**ARAPAHO ROAD – PHASE II
MARSH LANE TO SURVEYOR BOULEVARD**

ADDENDUM NO. 2

January 24, 2002

DRAWING "A-1"

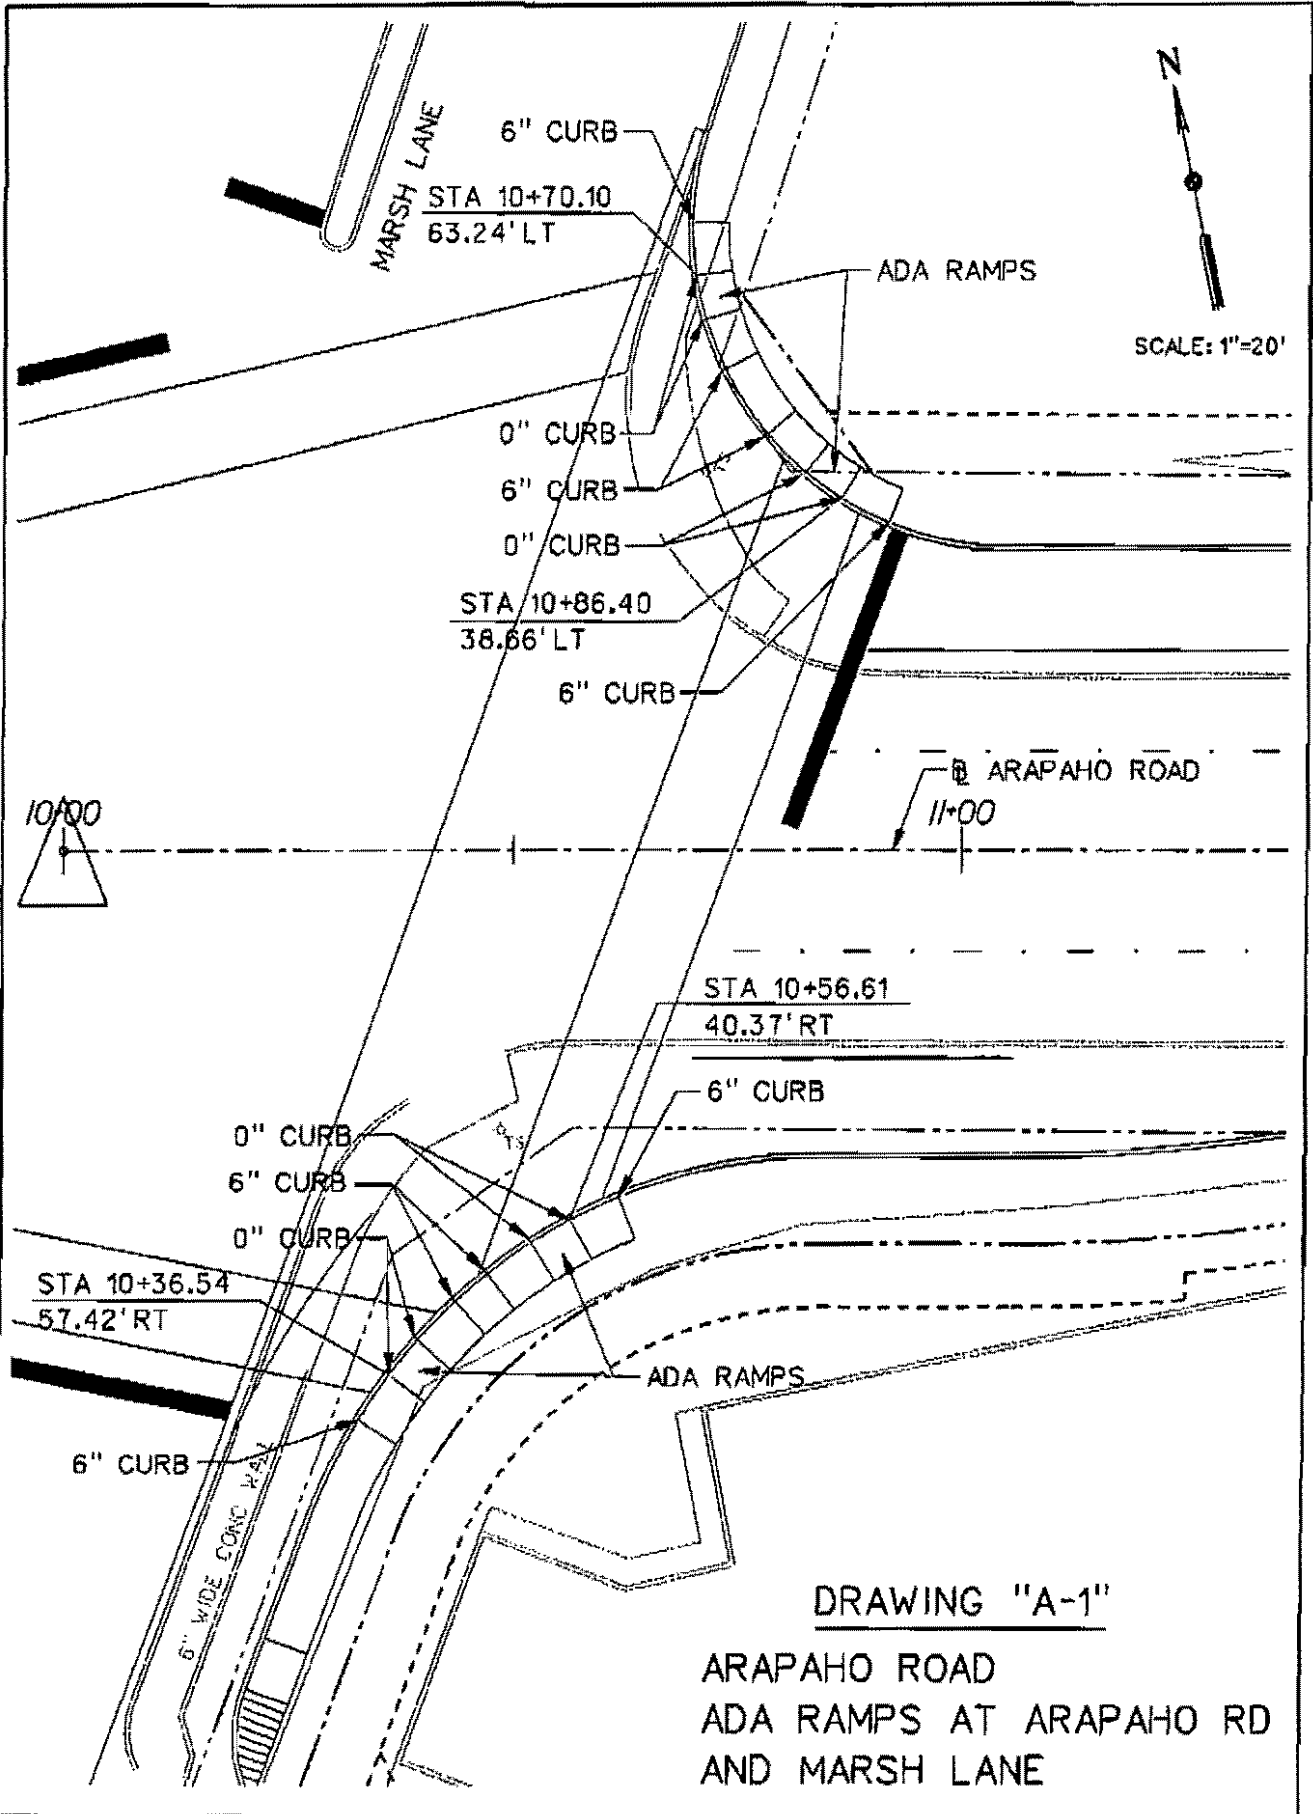
10. Sheet PP-2, Paving Plan and Profile: The proposed wheelchair ramps located on the northeast and southeast corners of the Marsh Lane and Arapaho Road intersection, shall be constructed as shown on the attached sheet, Drawing "A-1", Arapaho Road ADA Ramps at Arapaho Rd. and Marsh Lane.
